Lloyd's Register of Shipping.

Ship's Name DENBIGH COAST

Official No. 164312

Memorandum of alterations reported since ship was surveyed for assignment of Load Lines
in JAN., 1937.

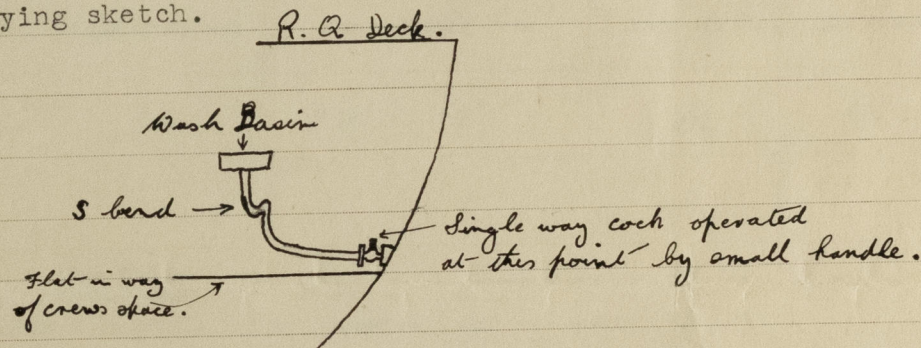
1. The only sanitary discharges from crew space below raised quarter deck are 3 wash basin discharges. Each of these is fitted with a single way cock fitted to the ship's side as shewn in the accompanying sketch.
